U. S. ARMY AC-1 DE HAVILLAND "CARIBOU" EVALUATION
Ft. Rucker, Alabama
21 January 1960

REPORT OF CRASH INJURY EVALUATION
A/CIR-14-PV-121
October 1960

United States Army
Transportation Research Command
Contract DA-44-177-TC-624

Figure 4. Front view of Caribou.

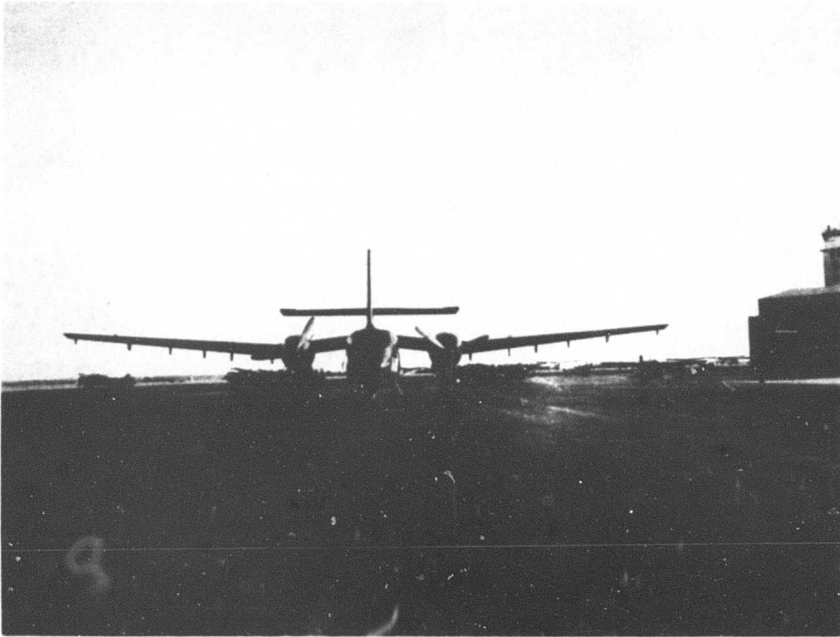
This gives the basic aircraft structure its main strength in the inverted U formed by the main landing gear and the connecting wing center section (Figure 4) and indicates the advisability of making a crash landing with the main landing gear extended, regardless of terrain.

Therefore, a flat terrain should be selected and the aircraft should be flown in rather than dropped in to prevent crushing of the cabin compartment by the heavy super-structure.

1. If conditions permit, crash landings be made with the landing gear extended, regardless of the terrain used.
2. If landing gear malfunction dictates a wheels-up landing, flat terrain be selected and the landing technique be aimed at minimum vertical load at touchdown.

Figure 5. Pilot's seat.

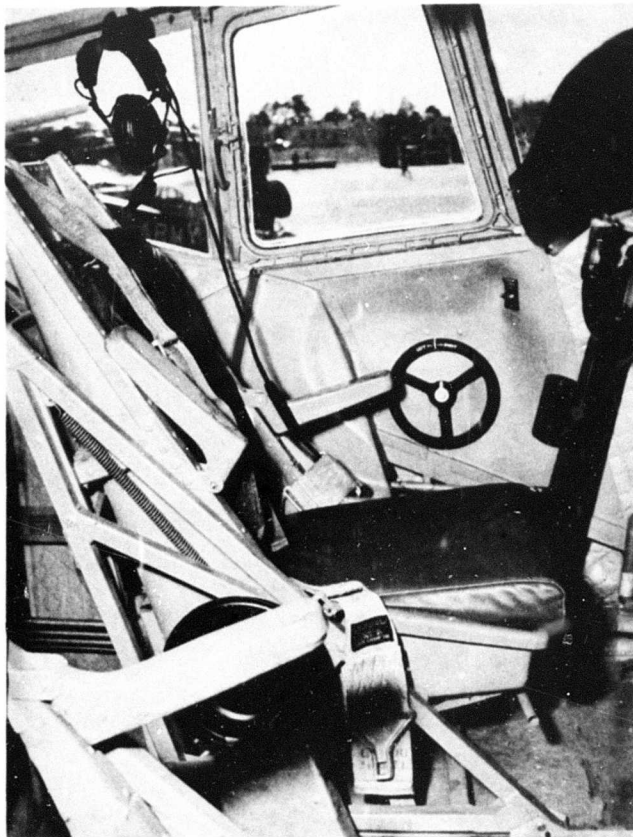
Attachment of the seat belt and shoulder harness to basic aircraft structure would relieve the seat of much of the crash load during crash deceleration and offer some form of occupant protection even when the seat tie-down failed. On the other hand, it is realized that this would entail certain inconveniences for the occupant because vertical seat adjustment would always necessitate seat belt adjustment while shoulder harness adjustment might be necessary before or after vertical and/or horizontal seat adjustment. Based upon this analysis, it appears advisable to have the seat belt attached to the seat as presently attached.

The manner of shoulder harness attachment cannot so easily be decided. The advantage of attaching the shoulder harness to basic aircraft structure is unquestionable since it eliminates the torque on the seat exerted by a shoulder harness anchored to the seat. This advantage must be weighed against some of the problems that may be encountered.

The vertical seat adjustment system creates a hazard under certain conditions. A person (crew chief or troop commander) standing in the aisle behind and below the crew seats would probably support himself by placing his hand against the open frame work in which the seat moves up and down. This would expose his hands to injury in case of vertical seat adjustment by one of the crew members.

2. The width of the shoulder harness guide on top of the crew seat backs be reduced to increase lateral support during side load conditions.
3. The inertia reel in the Caribou be replaced by a model that ensures positive locking of the shoulder harness regardless of the direction of crash force.

4. Consideration be given to anchoring the shoulder harness to basic aircraft structure in a manner that precludes undue inconvenience to the crew members.

5. The inboard sides of the crew seats be shielded in a manner that precludes injury to a person supporting himself against these seats.
6. The present ultimate sideward and upward load characteristics of the crew seats be re-evaluated to determine whether these loads are compatible with the forward strength characteristics of the seats.

Figure 6. Right side of the cockpit, showing overhead location of engine controls.

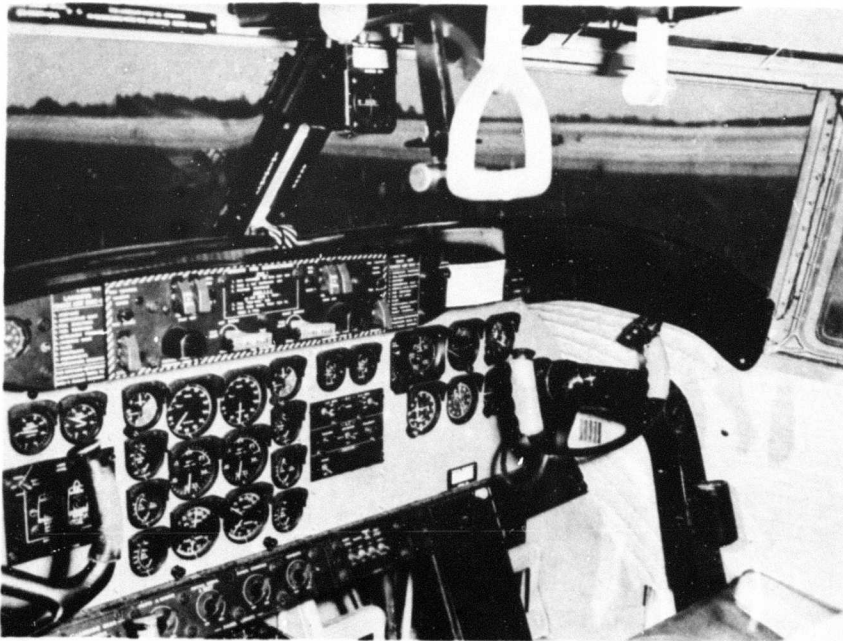
Although the tie-down strength of this console could not be accurately assessed, it can be stated that its resistance against abrupt decelerations should be at least equal to that of the crew seats to prevent it from becoming a dangerous projectile or imposing an additional load on the adjacent seat attachments.

1. The tie-down strength of the radio console in the fore and aft position be subject to a critical examination to determine its compatability with the tie-down strength of the crew seats.

Figure 10. The two auxiliary ramps (1 and 2) are stowed against the ceiling in the aft fuselage above the cargo door.

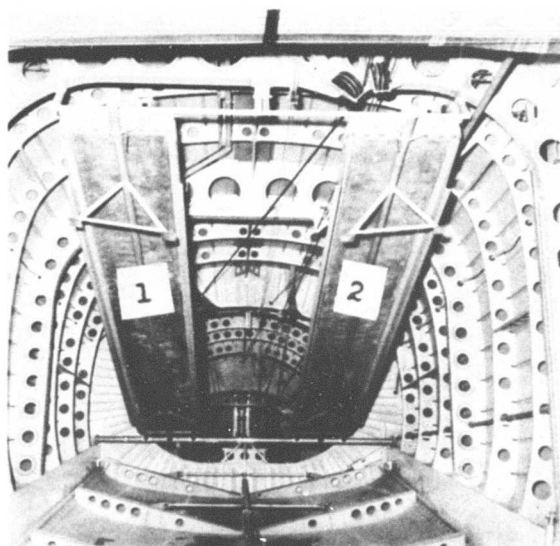
Two auxiliary ramps, to facilitate loading wheeled vehicles, are stowed against the ceiling in the aft fuselage above the cargo door (Figure 10). It is impossible to make an analysis of the tie-down strength of this installation based upon the available data. It can only be stated that these ramps would create a serious hazard for the cabin occupants if they became dislodged as a result of impact forces or distortion of the aft fuselage.

1. The cabin floor forms an excellent platform and will offer considerable crash protection.
2. The two auxiliary ramps, stowed against the ceiling in the aft fuselage, might conceivably become dislodged during a crash deceleration of sufficient magnitude and be hurled into the cabin.

1. The tie-down strength of the auxiliary ramps in the stowed position and the effects of aft fuselage distortion on the present installation be critically examined. (Stowage in the fuselage bottom or sides would simplify the tie-down problem and facilitate ground handling.)
2. The strength of troop seat lap belts and attachments as specified in MIL-S-5705 be increased to approximately 20 G.
3. The present troop seat specifications be subjected to a realistic appraisal in order to determine what steps can be taken to increase occupant protection.

Figure 14. Post-crash appearance of seats built in accordance with the same Military Specifications, installed in another aircraft, after a moderate impact. The arrows indicate failures.

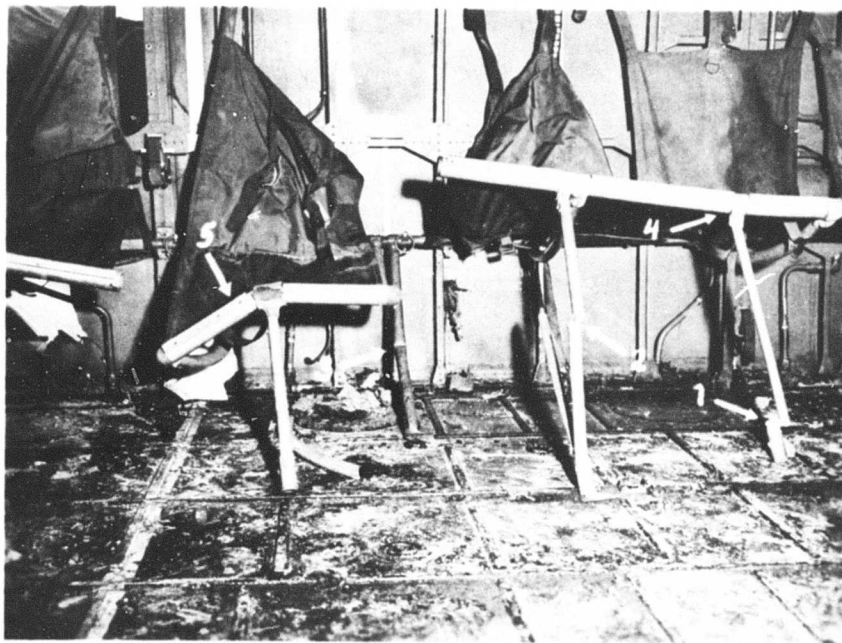
The effect of moderate crash forces on seats of similar design is shown in Figure 14. The seat legs and the front support tube failed in a manner that exposed the occupants to serious injury.

The side load strength requirement for this seat forms the main point of controversy concerning the adequacy of design. The seat is required to withstand an ultimate sideload of 225 pounds (1.1 G) applied in line with the center line of the front support tube. Since the seats are installed alongside the cabin walls (facing inboard), this load is applied parallel to the longitudinal axis of the aircraft and can actually be considered a forward load. In fixed wing aircraft this is often the direction in which a component of the main crash force is applied and for this reason most seats have their greatest strength in the forward direction. The foregoing should make it clear that in the case of the troop seat design requirements the situation is exactly reverse, that is, the seat has its lowest strength in the forward direction.

Figure 15. Static ultimate load requirements for seats, structures, and litters.

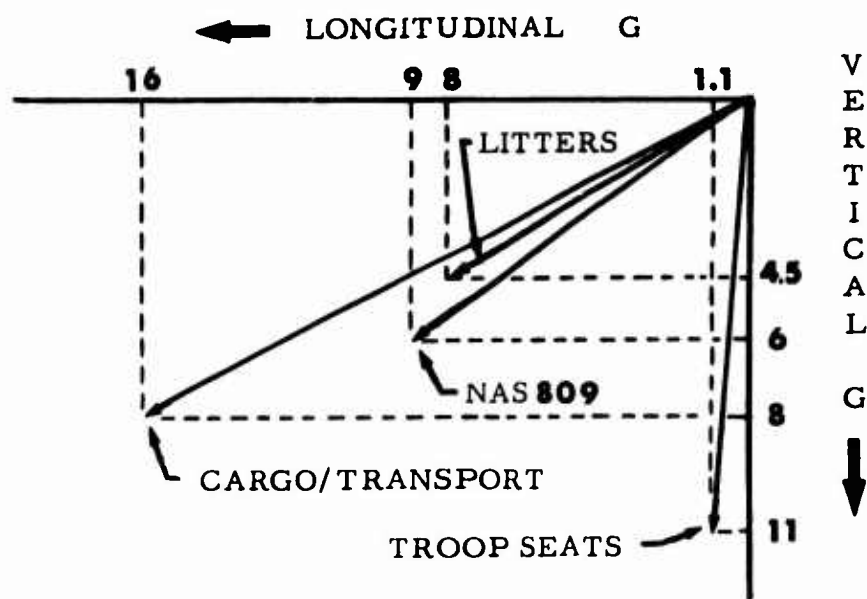
By making the favorable assumption that the static loads, which these structures must be able to withstand when applied separately, can also be sustained without failure when applied simultaneously, a more realistic approach to actual seat strength can be made. (See Figure 15.)

In this diagram the longitudinal and vertical load requirements have been combined to show the peak magnitude and optimum direction of crash force resultants sustainable by: Cargo/Transport aircraft structure; litters; passenger seats; and troop seats.

Figure 16. Ultimate load characteristics for seats, structures, and litters at 35° crash force angle.

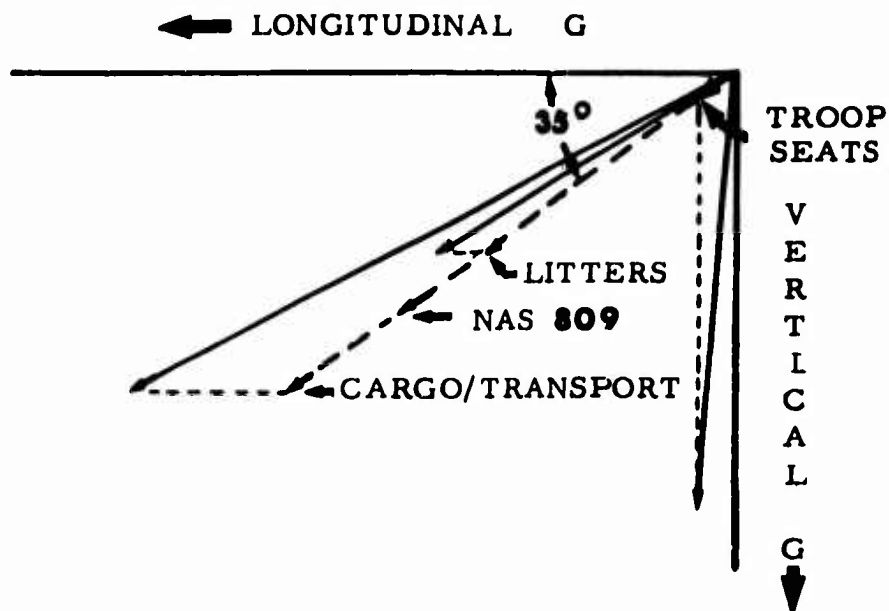
The resultant ultimate load characteristics of cargo/transport structure, litters, and troop seats have been transposed to a 35° vector, which coincides with the resultant of the NAS 809 passenger seat requirements. This angle was chosen because accident experience seems to indicate that this is an acceptable mathematical average of the directions of crash force application in survivable accidents. The results of this transposition can be summarized as follows: At a crash force angle of 35° the theoretical ultimate load strength of the subject structures is shown in Table 4.

Table 4 indicates clearly that the crash resistance of the troop seats under anticipated survivable impact conditions is inadequate.

Figure 17. The seat belts in the Caribou are directly attached to the clamps that secure the rear support tube to the basic aircraft structure (black arrow).

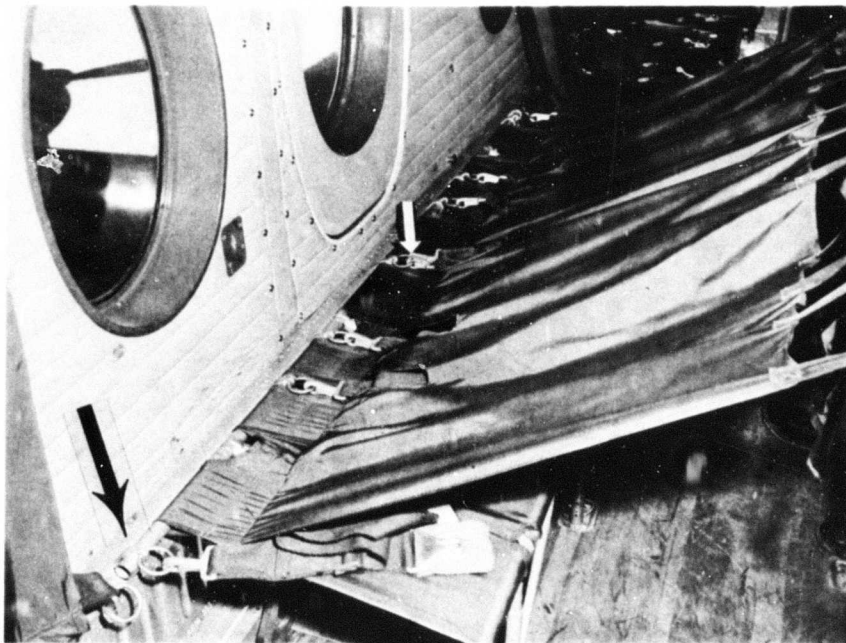
The manner in which the seat belts in the Caribou are anchored to basic structure (Figure 17) shows improvement over the anchorages observed in previously evaluated aircraft. The system of the "D" ring and the drilled hole in the rear support tube, which frequently led to failure at these points as indicated by accident experience, is replaced by a clamp around the support tube. At one end this clamp is attached to the basic aircraft structure and at the other end there is a ring for seat belt anchorage.

Figure 18. Litter and troop seat installations.

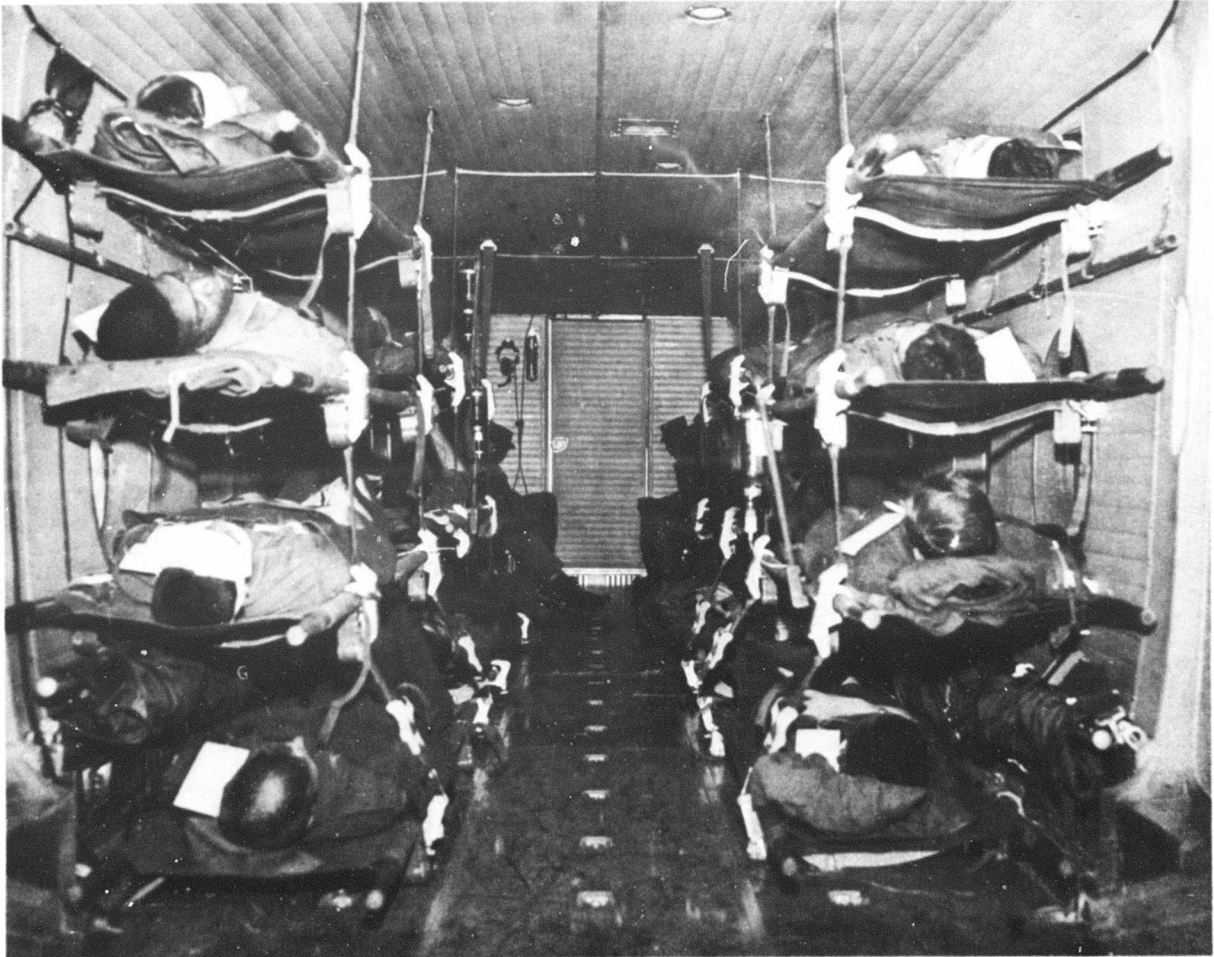
Seven litters, one stack of four and one stack of three, can be installed along both cabin walls (Figure 18). Each litter is mounted in two brackets on the cabin wall and two brackets on litter straps on the aisle side. The litter straps are anchored in the ceiling and in the floor.

In addition to being incomplete, these litter tie-down requirements are inadequate. Not only are they far below the recognized limits of human G tolerance (see Appendix I), but they also offer less crash protection than the tie-down requirements for passenger seats in transport aircraft* which are considered inadequate for survivable impact conditions.

4. The standard litter installation in Army aircraft, as used in the Caribou, be subjected to static or dynamic tests to (a) determine its ultimate load-carrying capacity in relation to the requirements in MILS-5705; and (b) the adequacy of these requirements in relation to survivable crash force conditions.

Figure 19. Emergency exit release of the cockpit escape hatch above the pilot's seat. The black arrow indicates the button that has to be pressed before the handle can be turned. Notice that the instructions do not refer to the button.

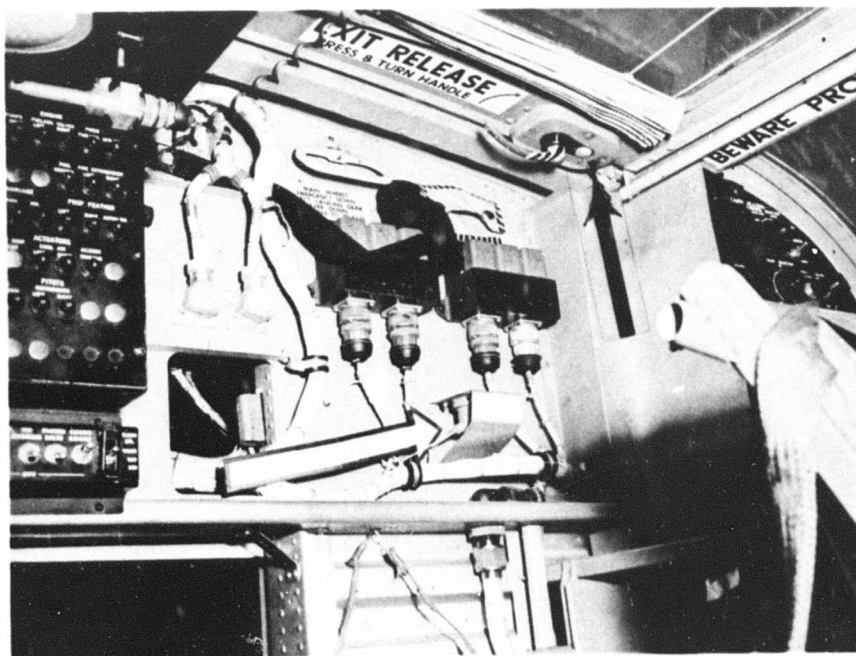
In addition to the bottom entry hatch, which can be jettisoned, there is an escape hatch in the cockpit structure above and behind the pilot's seat (Figure 19). The sliding windows on both sides of the cockpit provide alternate emergency exits. These arrangements plus the proximity of the cabin emergency exits to the flight crew area are adequate to permit rapid evacuation of the crew. To operate the top escape hatch a button must be pressed before the release handle can be turned. This button is rather small and flush with the surrounding surface. Quick manipulation of this button requires attention and accuracy. In conditions of darkness or crew incapacitation this could easily lead to delay in escape time.

Elimination of this button from the sequence of operation would facilitate operation and does not seem to constitute a hazard because the likelihood of inadvertent operation of this exit in the crew compartment by inexperienced personnel is practically non-existent.

1. The operation of the outside release of the emergency exit and the cockpit escape hatch be simplified by elimination of the button manipulation.
2. If these buttons are to be maintained, the related instructions be made more explicit and leave no doubt regarding sequence of operation and location of button.
3. The doors on opposite sides at the aft end of the cabin be made jettisonable.
4. The relocation of the troop seats with respect to the forward emergency exit (or vice versa) and the exit release handle be considered in order to determine the practicability of making this exit usable without removal of seat structure.

Figure 20. To open the guard covering the exit release of the cabin emergency exit (big arrow), the upper seat support tube has to be removed. This tube also shields the instructions on the guard.

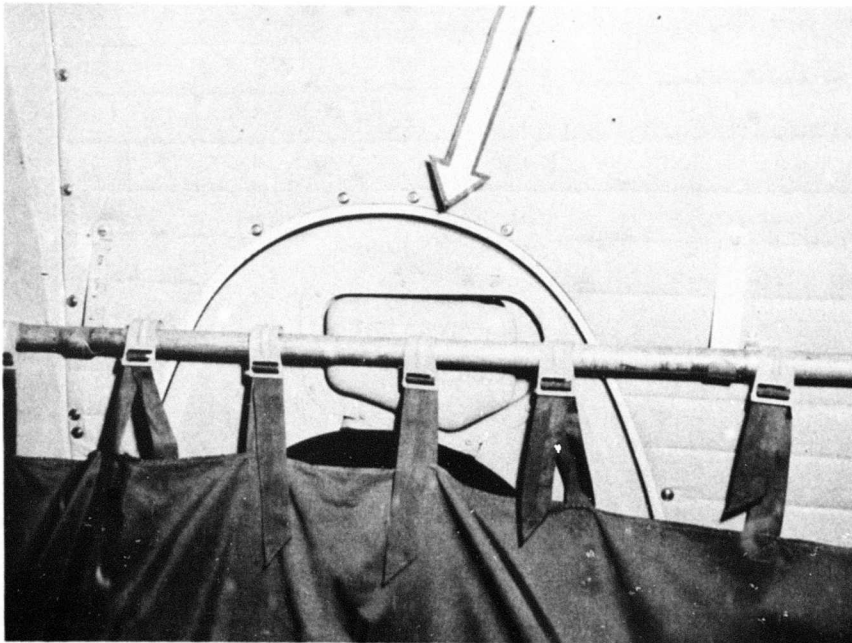
The cabin is equipped with an elliptical emergency exit located on the left side under the left wing. To operate this exit a handle must be turned which is covered by a guard. It will be noted in Figure 20 that this guard cannot be opened unless the upper seat back support tube has been removed. This tube also shields the emergency instructions on the guard. Since the greater part of the emergency exit is covered by the seat backs, it may go unnoticed by less experienced passengers.

The effectiveness of this emergency exit and the ease of operation would be greatly increased if the open space between adjoining seats had been utilized (Figure 21). In addition, if the location of the exit release handle and guard were slightly changed (up or down) with respect to the upper seat support tube, this exit could be used without removal of seat structure.

Figure 22. The two doors on opposite sides at the aft end of the cabin (1 and 2) are not jettisonable.

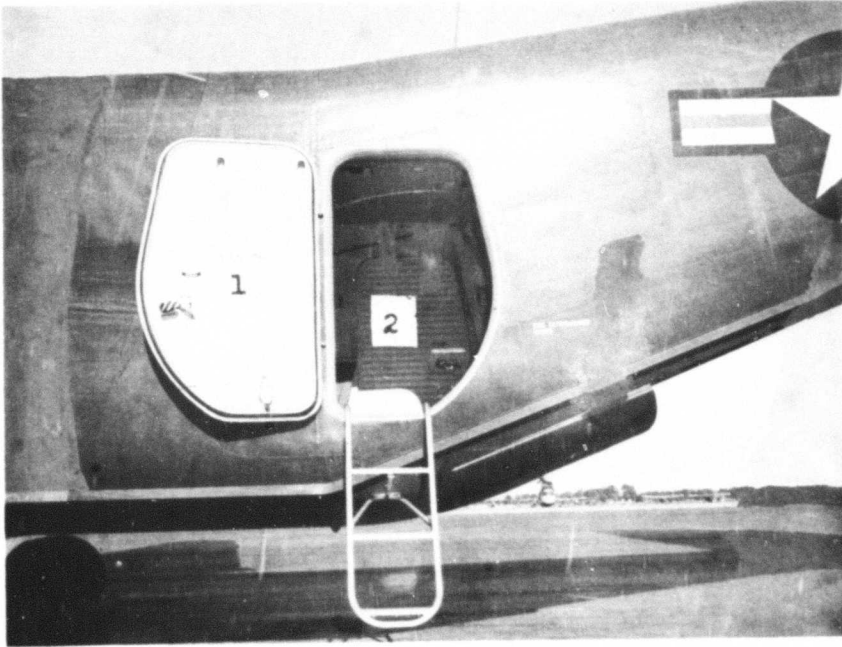
There are two doors (30 x 50 inches) on opposite sides at the aft end of the cabin (Figure 22). Although the one on the right is jettisonable according to the Model Specification, this was not the case in the model that was examined.

2. If these buttons are to be maintained the related instructions be made more explicit and leave no doubt regarding sequence of operation and location of button.
3. The doors on opposite sides at the aft end of the cabin be made jettisonable.
4. The relocation of the troop seats with respect to the forward emergency exit (or vice versa) and the exit release handle be considered in order to determine the practicability of making this exit usable without removal of seat structure.
5. An extra emergency exit be added to the right cabin wall and that its location and design be governed by Recommendation 4 above.

Figure 23. The rear cargo door retracts in the roof structure of the aft fuselage (arrow). It can also be jettisoned.

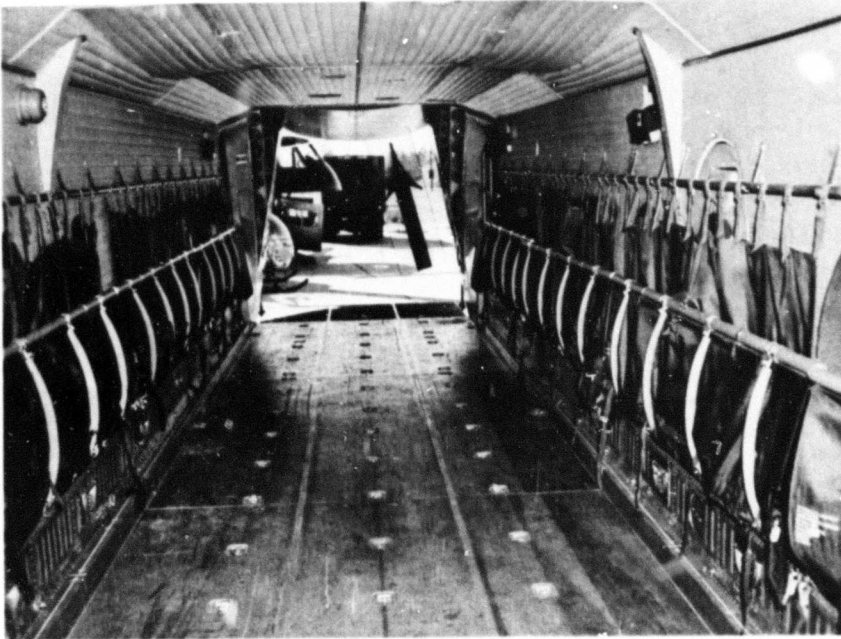
The rear cargo door provides a fourth emergency exit from the cabin compartment (Figure 23). The upper section of this door is jettisonable. The large size of this section and the manner in which it fits in the aft fuselage when in closed position make it very likely that this door will be jammed, when this part of the fuselage is distorted during a crash. Therefore, this door should not be depended upon as an emergency exit unless it is opened or jettisoned before impact. This further indicates the necessity of making both aft exits jettisonable.
